Re: 14th & Ursula Mixed-Use (DA-1279-53 / 2022-4021-00) / 1st Review Comment Response

Second Submission Review

14TH & URSULA APARTMENTS
 SITE PLAN
 AURORA, COLORADO

SHEET TITLE:
 GRADING AND UTILITY PLAN

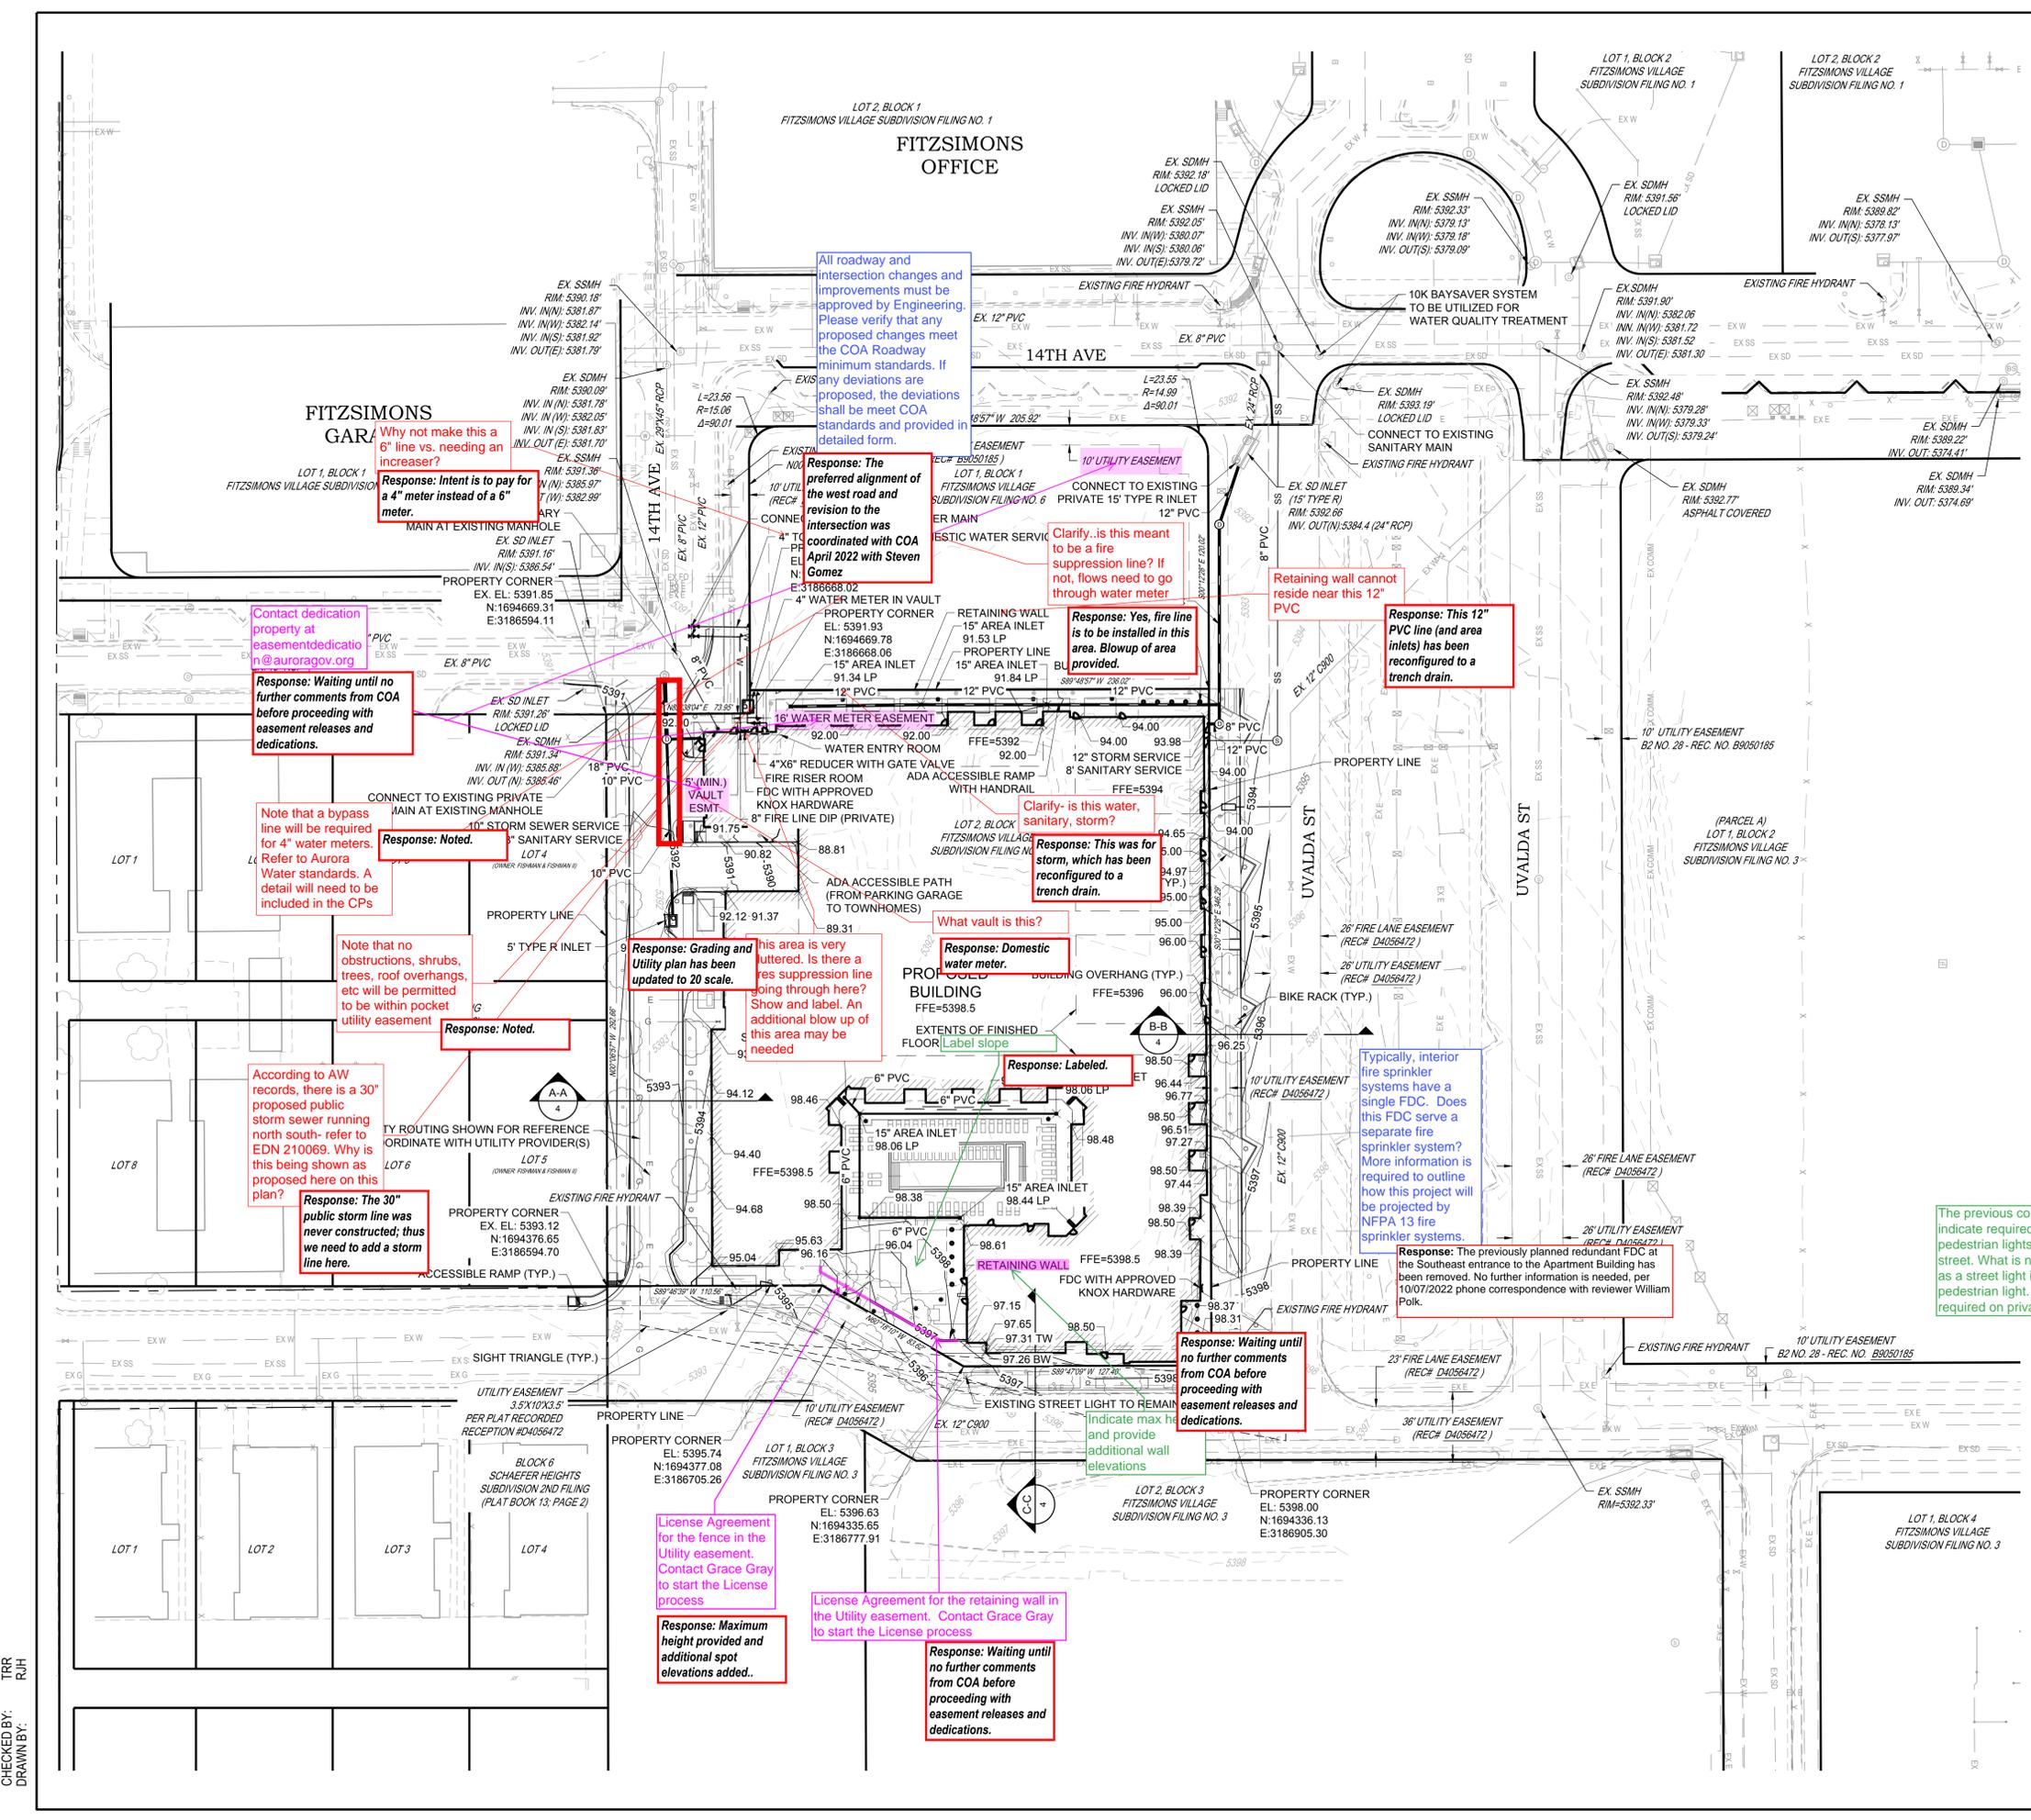
Why not make this a 6" line vs. needing an increaser?
Response: Intent is to pay for a 4" meter instead of a 6" meter.

Note that a bypass line will be required for 4" water meters. Refer to Aurora Water standards. A detail will need to be included in the CPs
Response: Noted.

Note that no obstructions, shrubs, trees, roof overhangs, etc will be permitted to be within pocket utility easement
Response: Noted.

According to AW records, there is a 30" proposed public storm sewer running north south- refer to EDN 210069. Why is this being shown as proposed here on this plan?
Response: The 30" public storm line was never constructed; thus we need to add a storm line here.

All roadway and intersection changes and improvements must be approved by Engineering. Please verify that any proposed changes meet the COA Roadway minimum standards. If any deviations are proposed, the deviations shall be meet COA standards and provided in detailed form.

Clarify... is this meant to be a fire suppression line? If not, flows need to go through water meter

Clarify- is this water, sanitary, storm?
Response: This was for storm, which has been reconfigured to a trench drain.

What vault is this?
Response: Domestic water meter.

The previous comment was to indicate required street lights, not pedestrian lights that are on the street. What is now being labeled as a street light is still a pedestrian light. Street lights are required on private streets
Response: Comment has been discussed with Kristin Tanabe. These are private streets and the team will be moving forward with keeping current configuration of street lights.

Response: Maximum height provided and additional spot elevations added.

Response: The preferred alignment of the west road and revision to the intersection was coordinated with COA April 2022 with Steven Gomez

Response: Yes, fire line is to be installed in this area. Blowup of area provided.

Response: The previously planned redundant FDC at the Southeast entrance to the Apartment Building has been removed. No further information is needed, per 10/07/2022 phone correspondence with reviewer William Polk.

Entry Illustration from corner of 14th & Uvalda

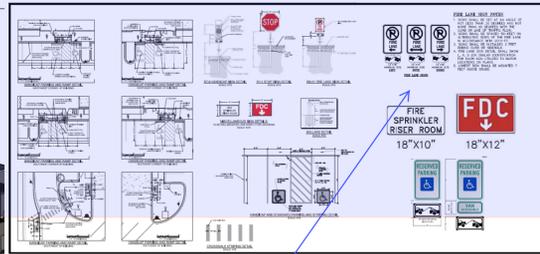
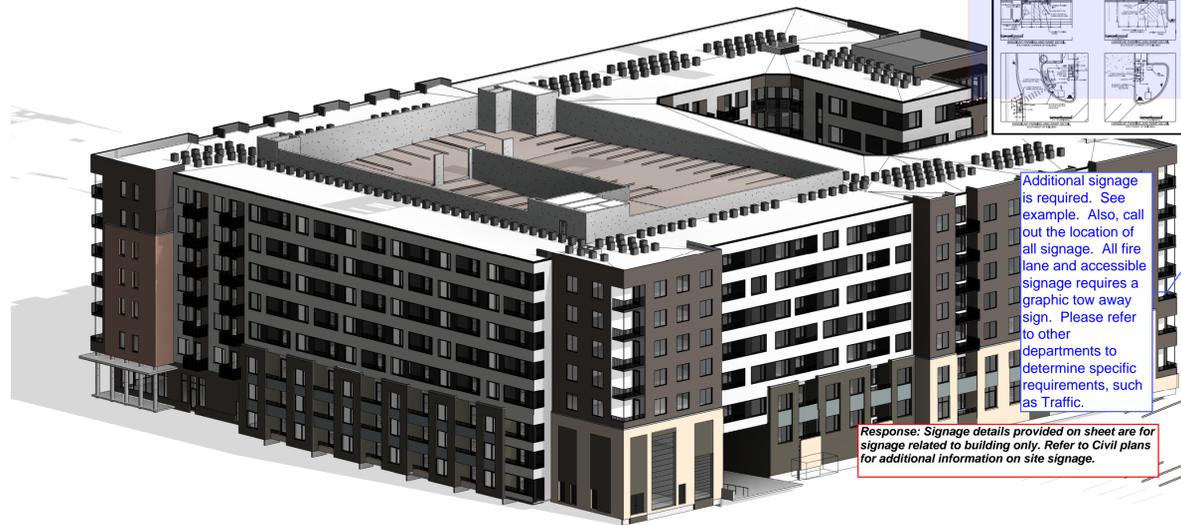
Additional signage is required. See example. Also, call out the location of all signage. All fire lane and accessible signage requires a graphic tow away sign. Please refer to other departments to determine specific requirements, such as Traffic.

Provide the a scalable measure showing the height of this element.

Additionally, provide a code analysis on how this site arrived at the indicated height.

Please show the measurement from the highest occupied floor located above the lowest level of fire department vehicle access.

Provide a spot detail showing the Fire Riser Room exterior door and the FDC location to ensure there are no visual or physical obstructions blocking access to fire elements or hindering responses from first responders.

Response: Please reference updated North Elevation drawing for requested dimension of garage mechanical ventilation shaft, stair and elevator over-runs. Please refer to code summary for proposed and allowable building heights.

Response: Signage details provided on sheet are for signage related to building only. Refer to Civil plans for additional information on site signage.
